CVS Expansion

Northgate Plaza

CONTEXT: NORTHGATE RENOVATIONS: CVS & HR BLOCK

**NORTHGATE PLAZA
AUBURN STREET
PORTLAND, MAINE**

ELECTRICAL CONNECTION PLAN 1 OF 1

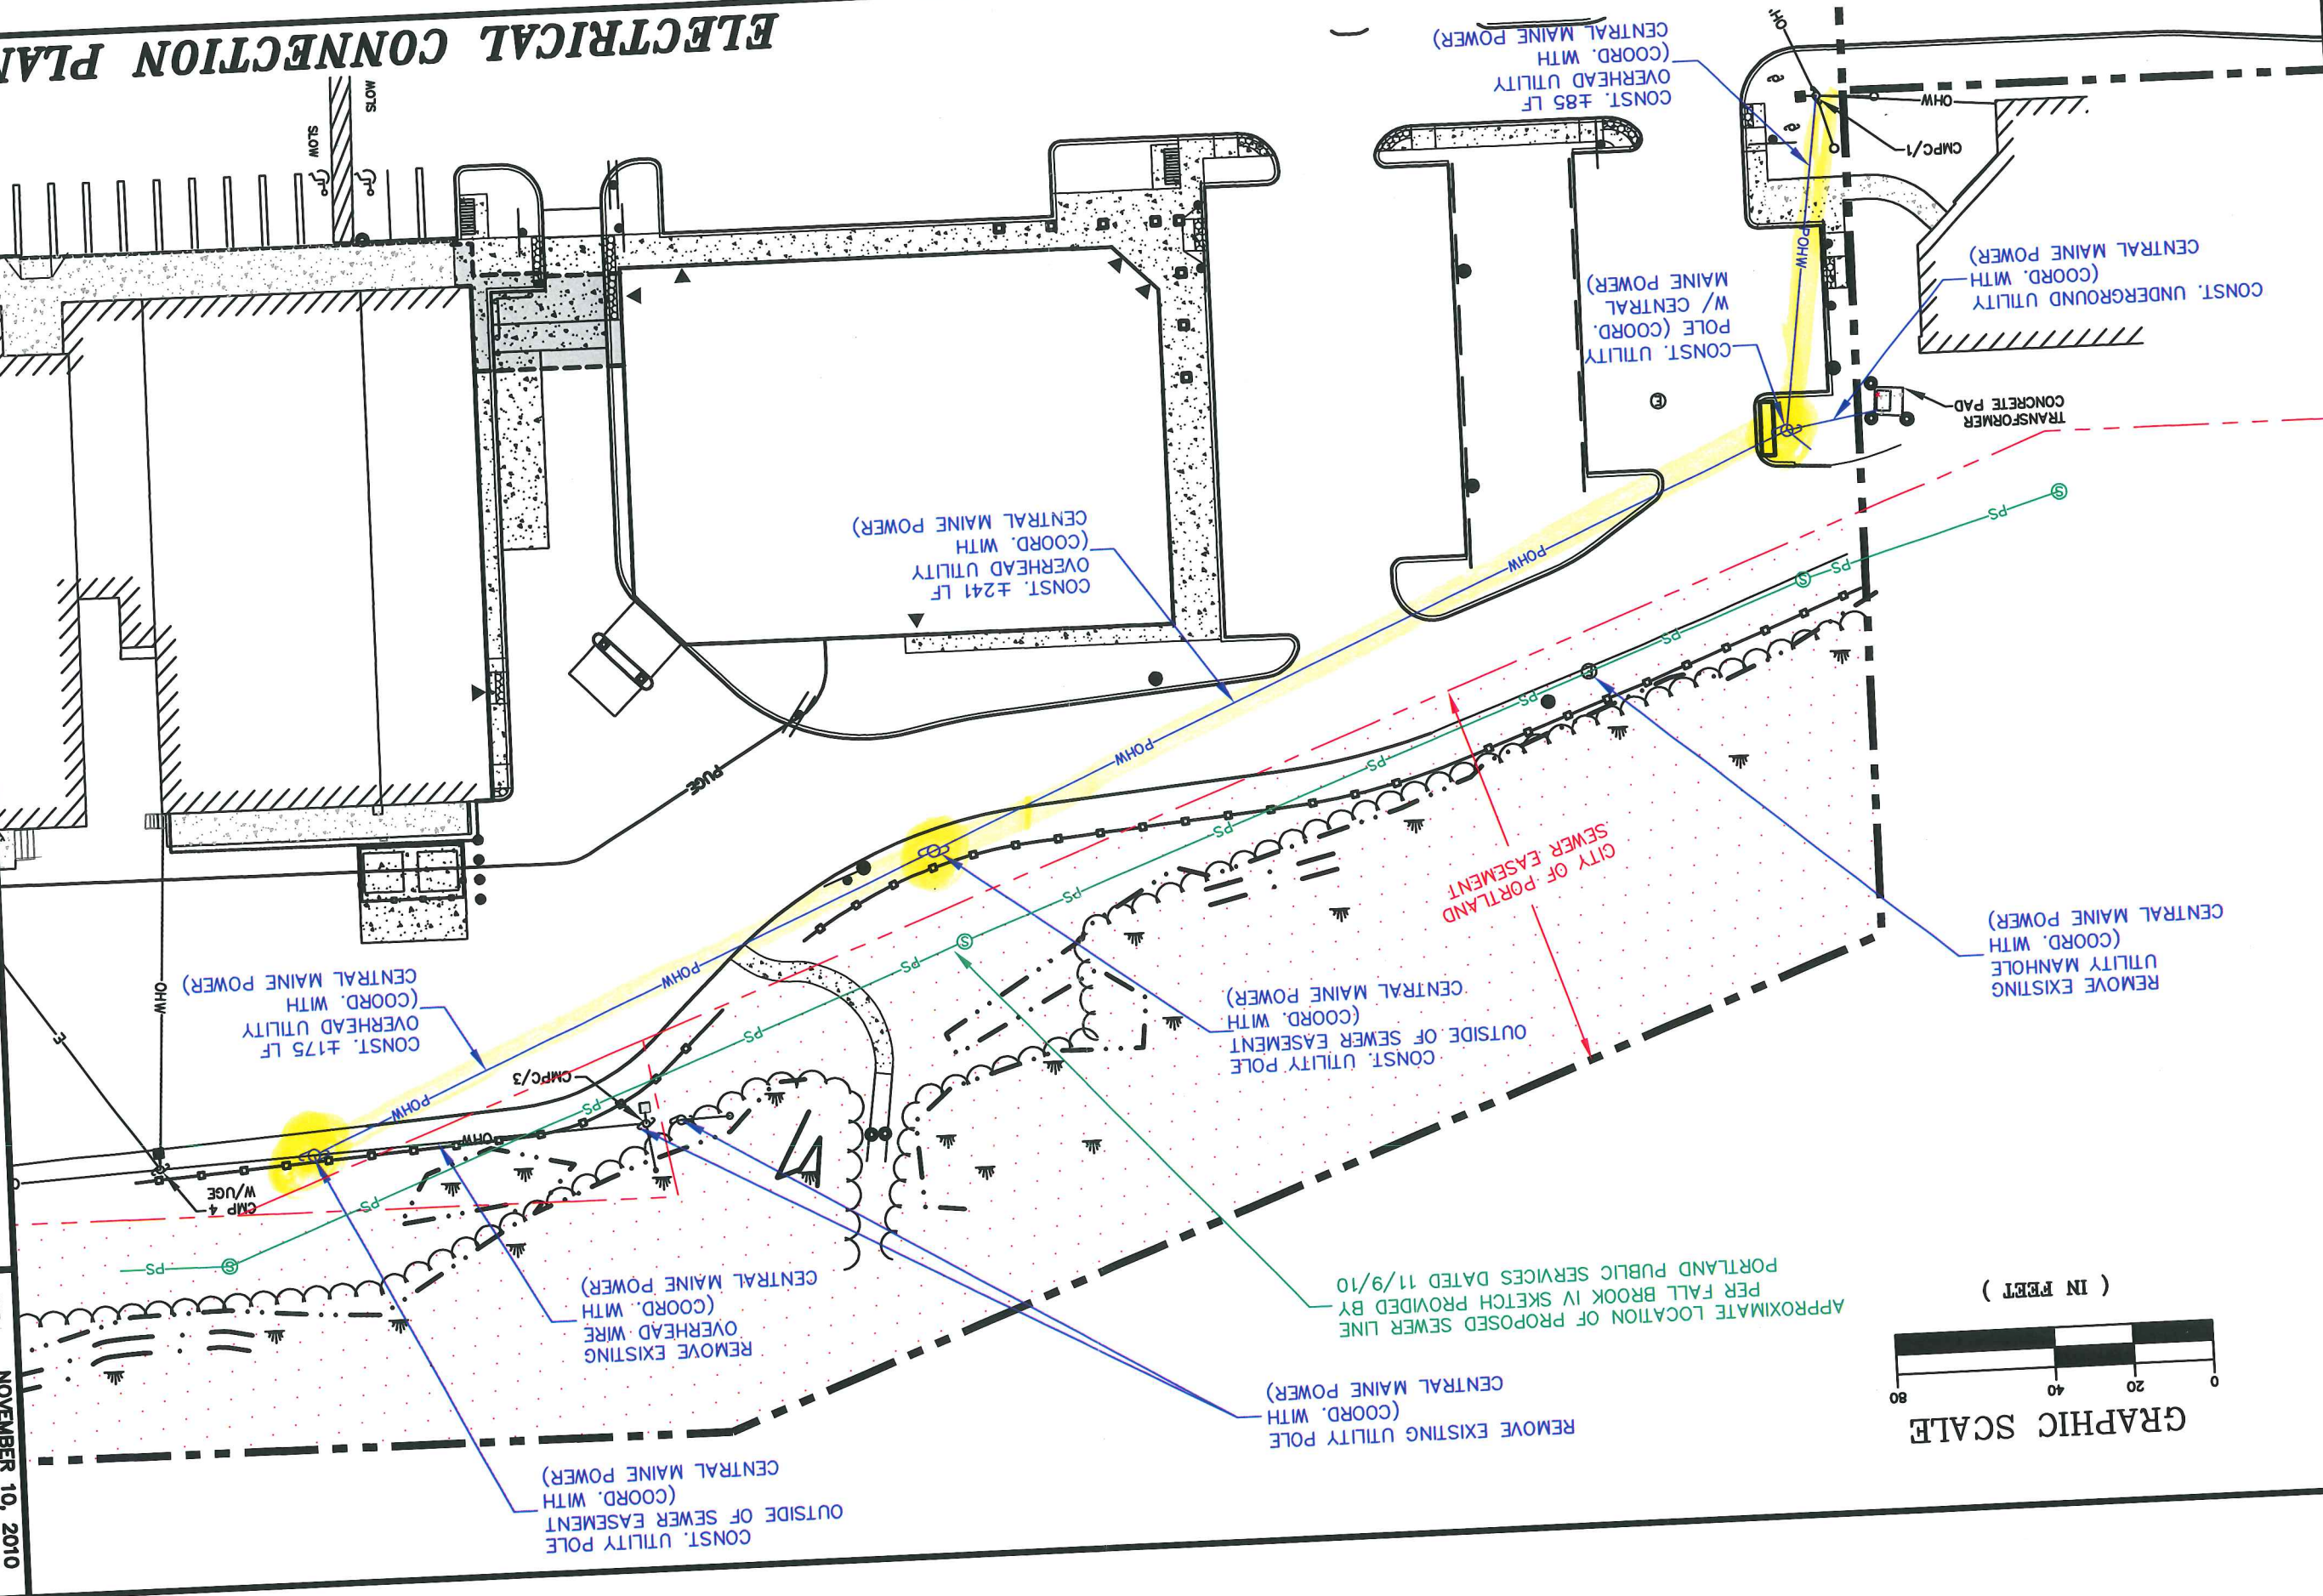
- red - where currently underground
- blue - where approved to be underground
- yellow - where proposed to be over-lead

discussed BB 11-19-10
 OK KF
 draft approval

2 SIDE ELEVATION
 SCALE: 1/8" = 1'-0"

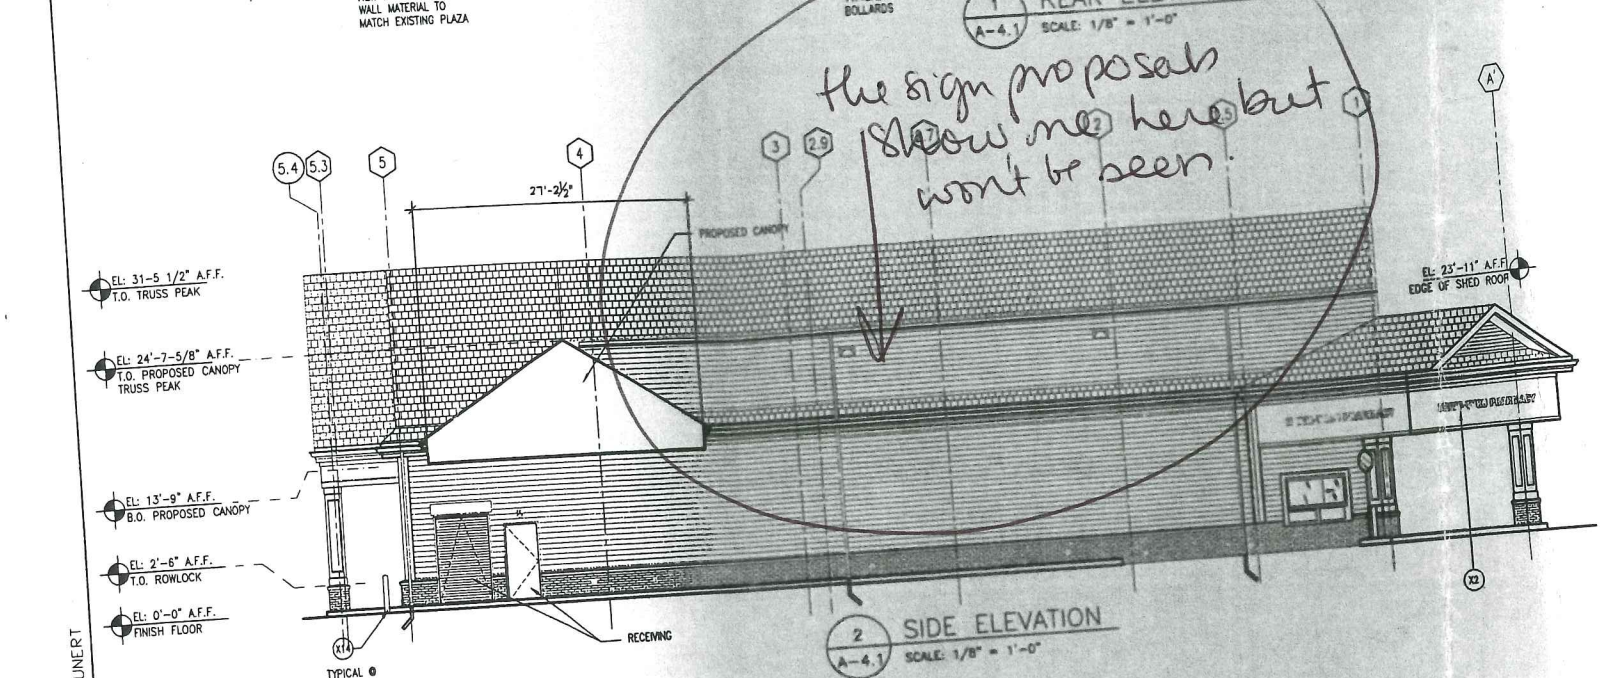
the sign proposals show me here but won't be seen.

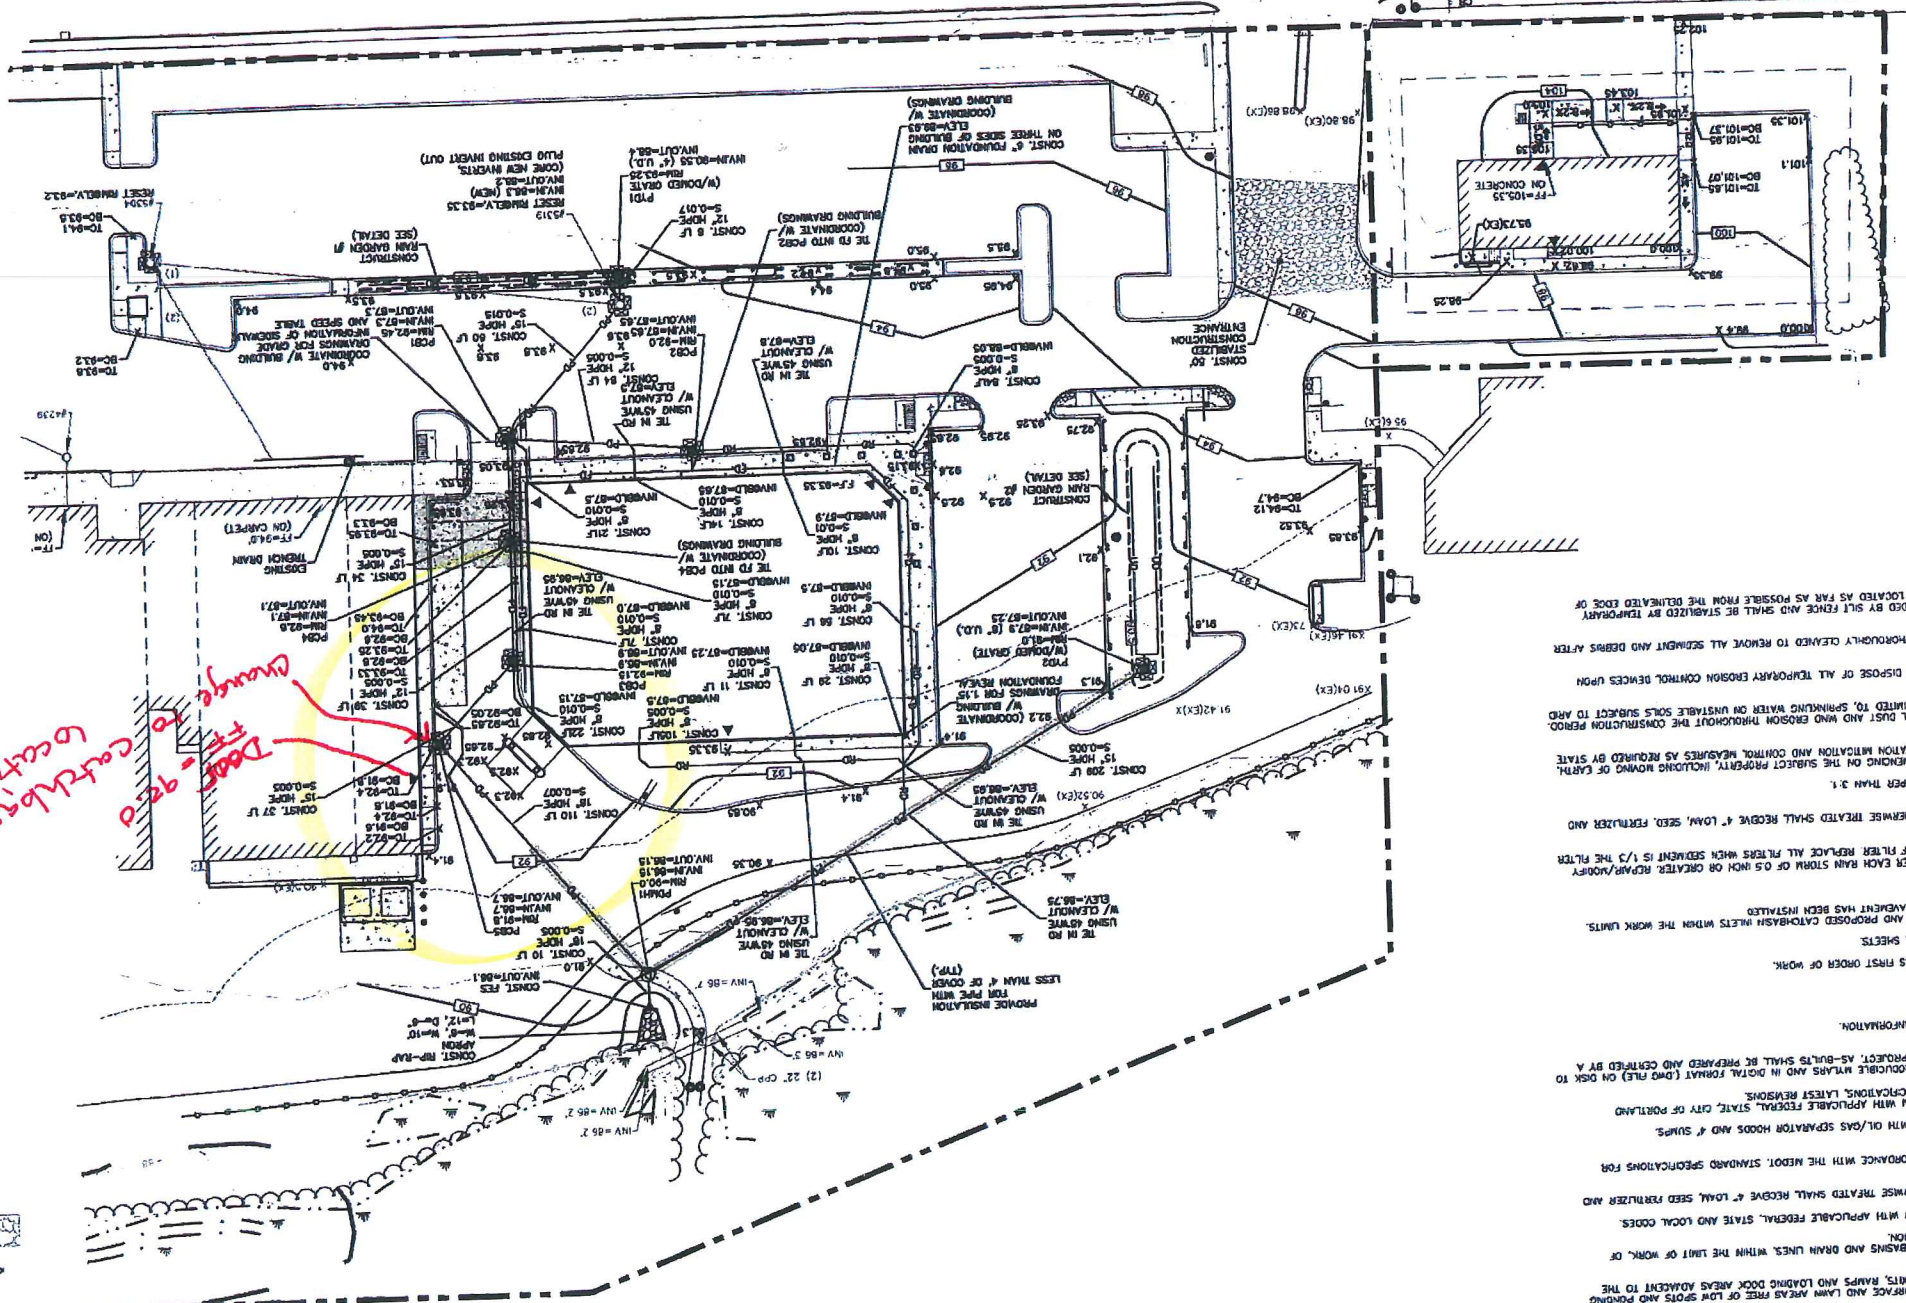
*Change to catchbasin location
 Door = 92.0*
